**EMERGENCY PIER 40 ELEVATED WALKWAY REPLACEMENT
CONTRACT NO. C4995
QUESTIONS & ANSWERS
OCTOBER 3, 2018**

PIER 40
Walkway Replacement

Contract No.	
Drawn by: BB	Sheet No. 6 of 7
Approved by: AS	
Scale: As Noted	S-1.3
Date: 08/24/18

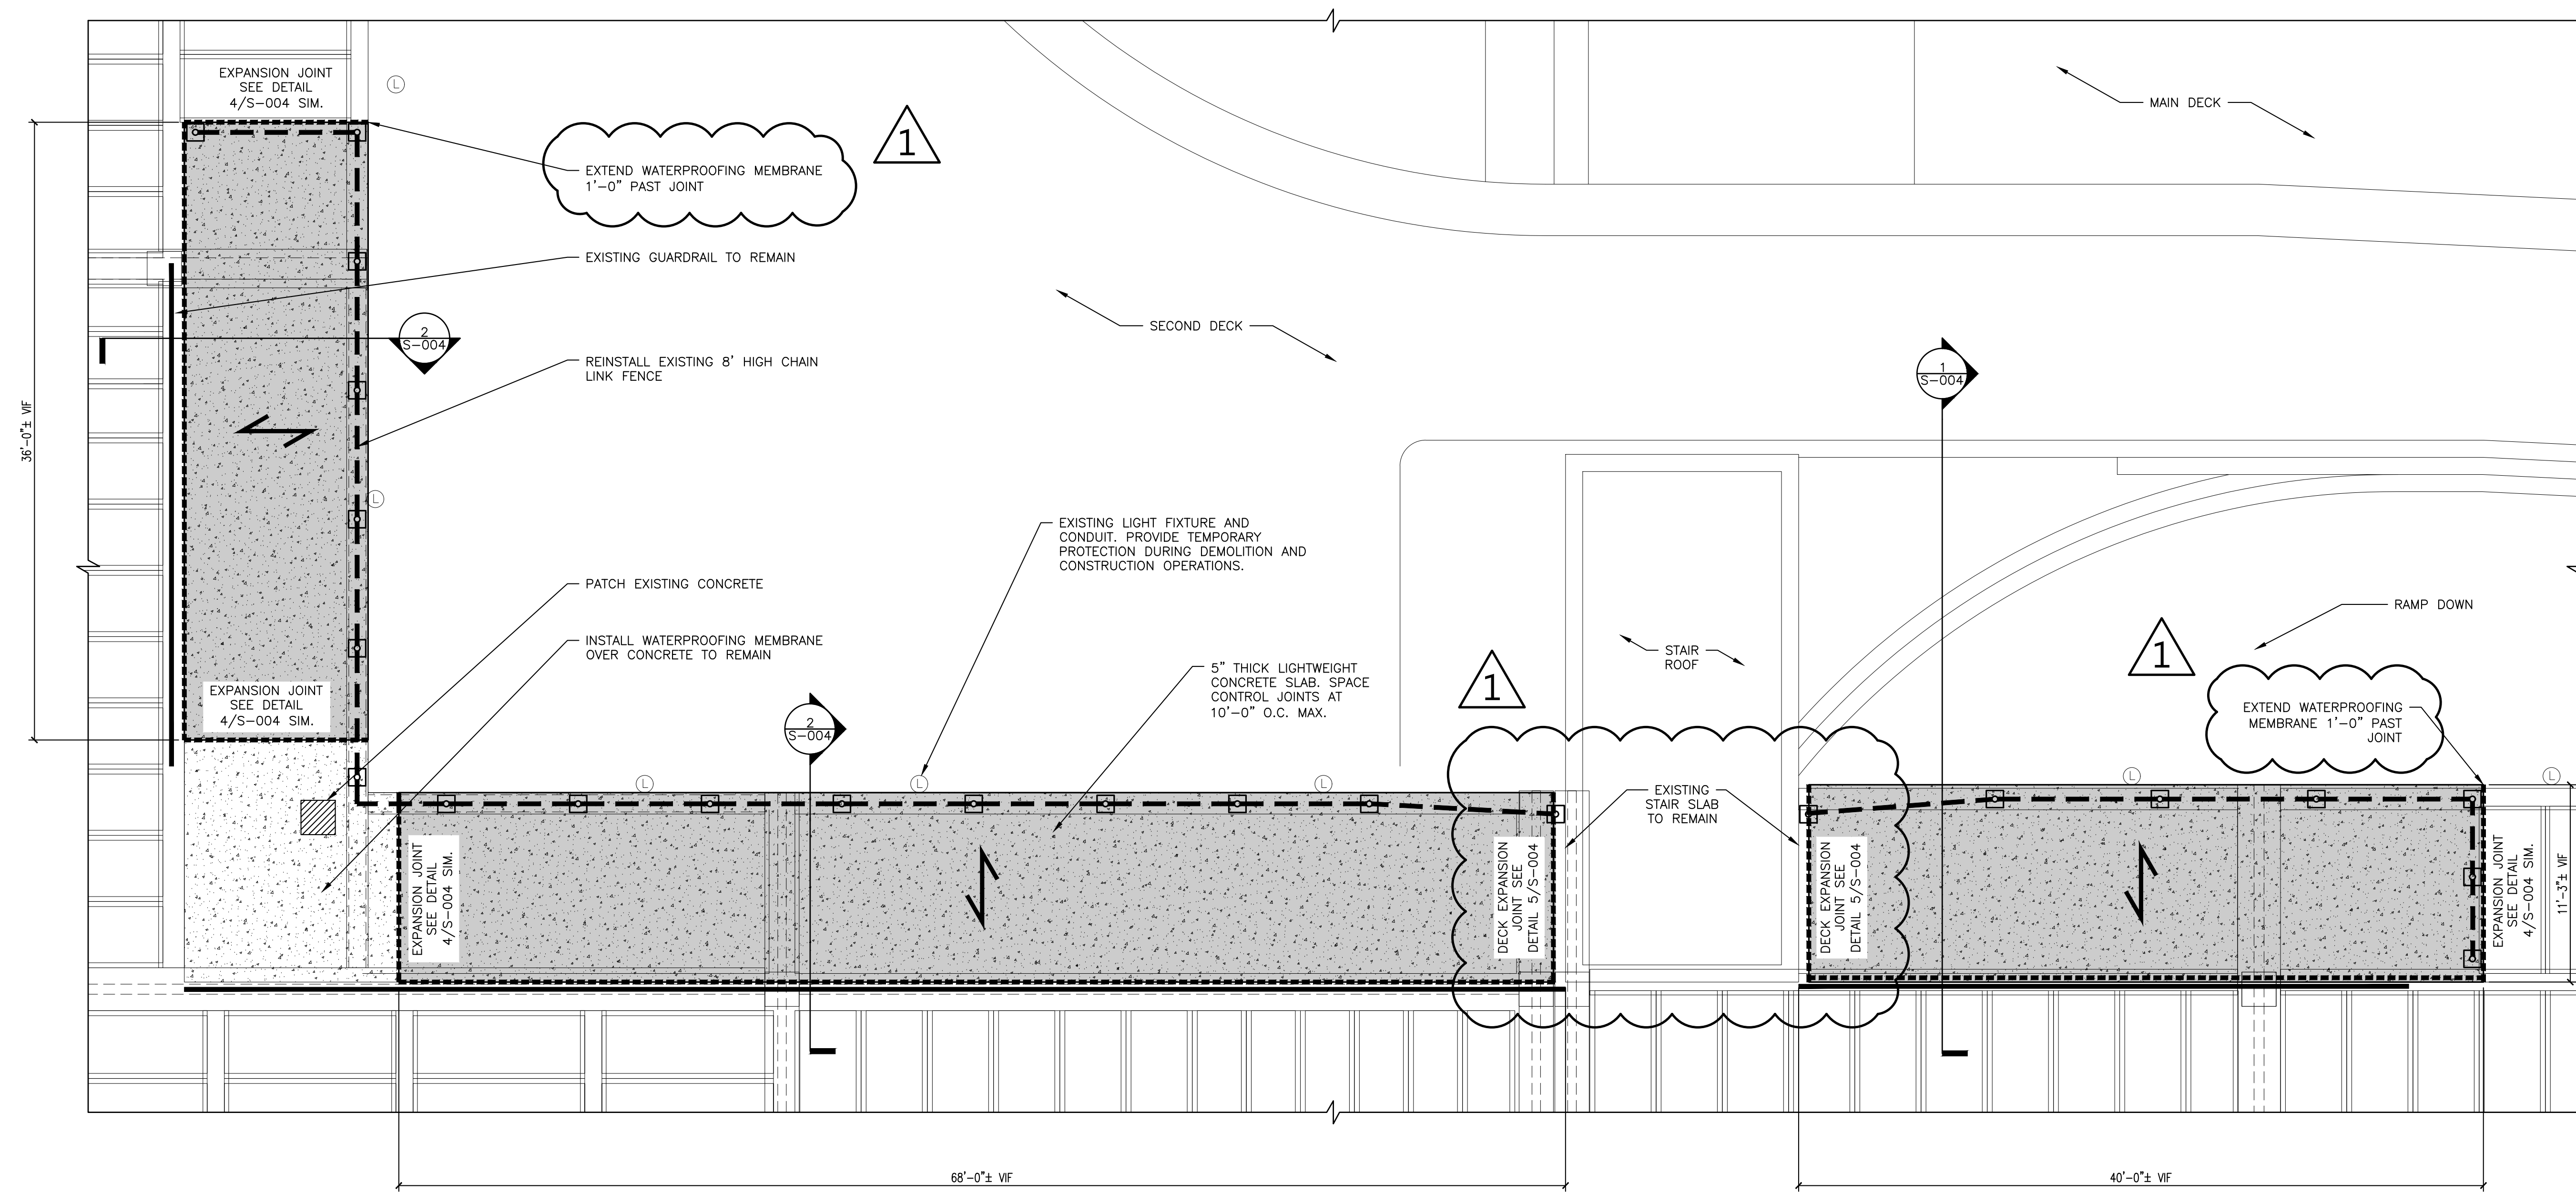
- 4. Q: According to provided drawings S1.3 & S1.4 the slab replacement goes up to the staircase walls which would include a portion of cast-in-place concrete slab, not concrete topping over metal deck, & existing expansion joint facing the South wall of the staircase.**

- Are the mentioned portion of cast-in-place concrete slab & expansion joint part of this repair work?**

- **If so, then provide a proper detail for this work showing the required expansion joint as well as technical specification for the new expansion joint.**

A: The concrete slab portion of the stairs is to remain in place and a deck expansion joint is to be installed between the new cast in place slab and the existing. The attached drawings have been updated to reflect the condition and the deck expansion joint detail has been added, and specifications have been attached for the expansion joint material.
